Subject Property: 5A Lorenz Industrial Parkway, Ledyard

Plan Designed by: Peter Gardner, L.S. Plan Date: **10/1/2024** Last Revision Date: **12/11/2024** Date Paid: **11/15/2024**.
The plan and associated information submitted to our office on **11/14/2024** for a proposed 2 office commercial building with public water and private septic at the above stated property, in the Town of Ledyard, is:

☒ **Approved w/conditions: Complies with the requirements of Section 19-13-B103 of the Connecticut Public Health Code; See conditions below.**

**PLAN SHOWING
PROPOSED BUILDING
ON PROPERTY OF
A & R ASSOCIATES INC.
5A LORENZ INDUSTRIAL PARKWAY
LEDYARD, CONNECTICUT
SCALE: 1"=20'
OCTOBER 2024
REVISED: DECEMBER 11, 2024**

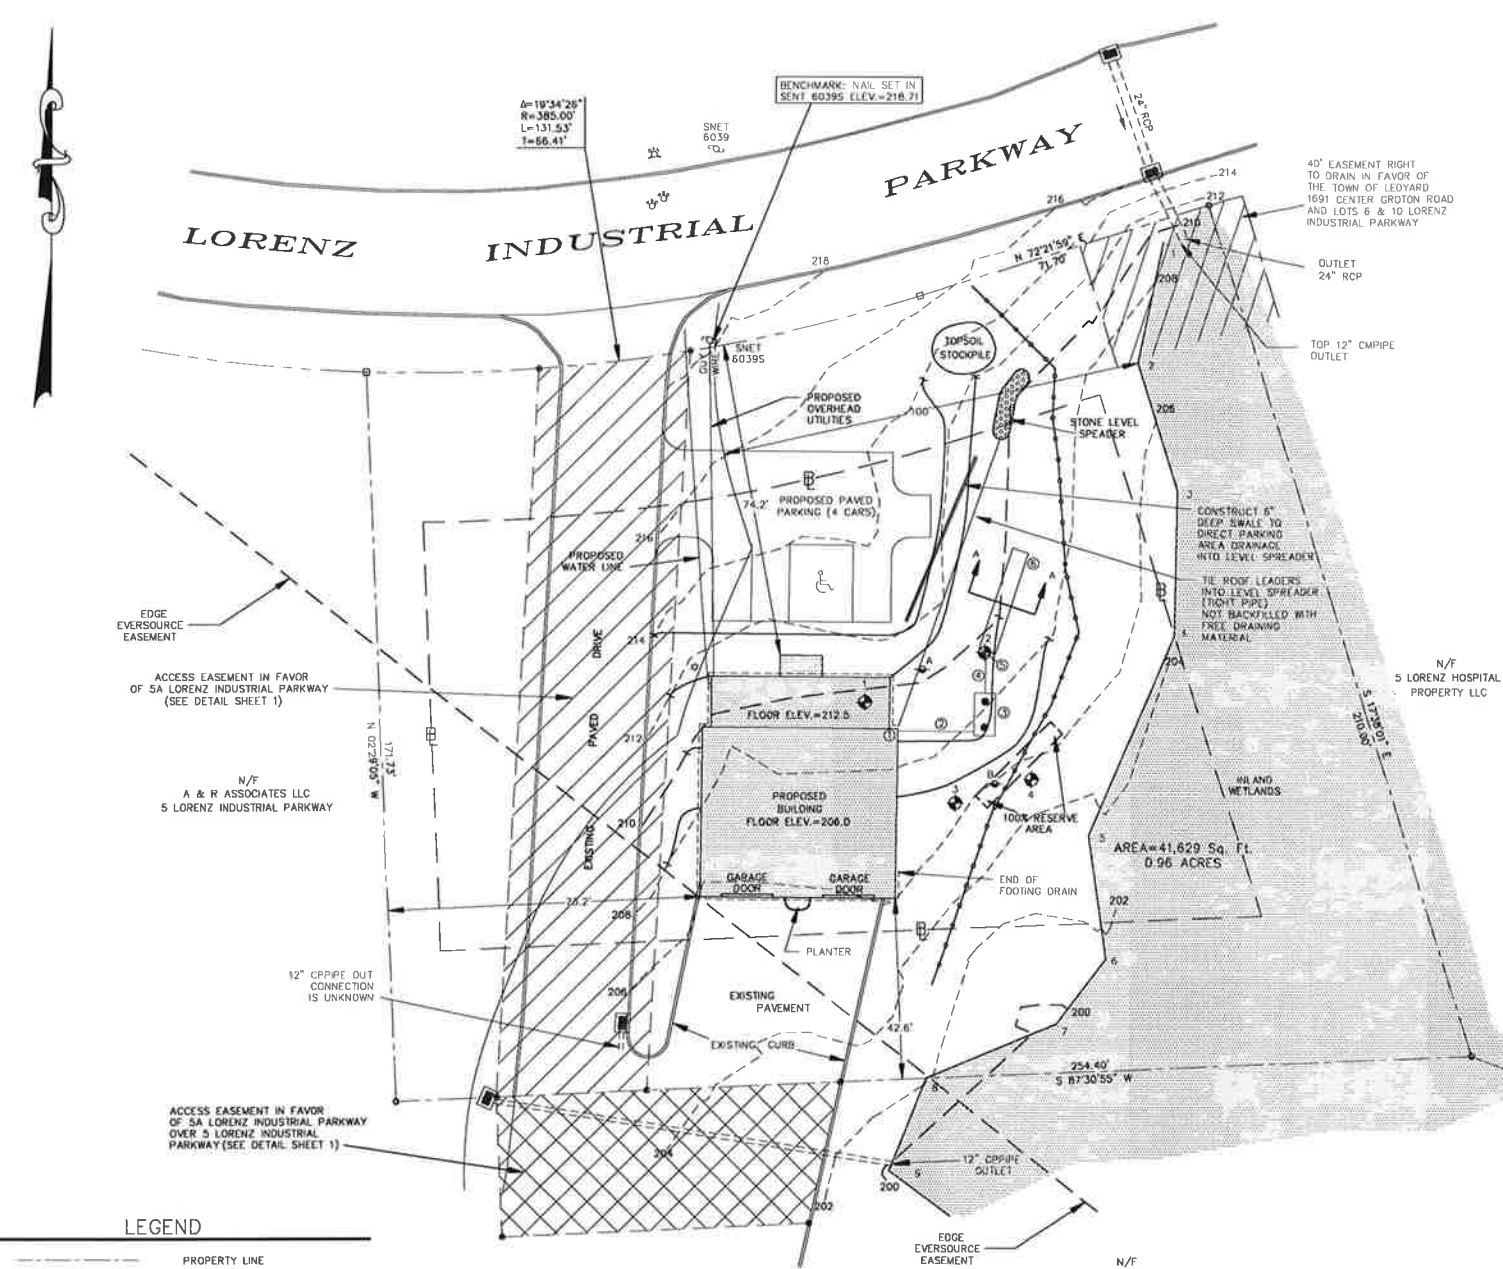
1. The plan proposes one row of 25LF in length, of Mantis 536-8 Low Pro to be set at a base elevation of 207.00', and gravity fed by a minimum 1000-gallon tank.

2. Confirmation test pit required at Northeast end of the primary leach field prior to installation.
3. A walkthrough upon completion of the construction of the house will be required prior to the issuance of the permit to discharge.

4. Footing drains shall remain >25' from all septic components. Shall be tight piped anywhere within 25" and the trench shall be backfilled with non-free drainage material.

5. A full sized to scale print of approved plan shall be provided to LLHD prior to issuance of the permit to install.
6. Stable benchmark adjacent to proposed building and sewage disposal system. Installer should not be required to transfer benchmarks when considerable difference (more than 10' to 15') exist between the benchmark and leaching area. If the benchmark is disturbed prior to construction, the engineer should set another one for construction purposes.

7. All tanks requiring risers shall maintain the original covers on the tanks, have riser covers that weight at least 59 lbs. and/or install a safety device below the riser to prevent individuals from falling into a tank. All below grade tank or riser cover handles shall contain or be fitted with a material that can be located with a metal detector
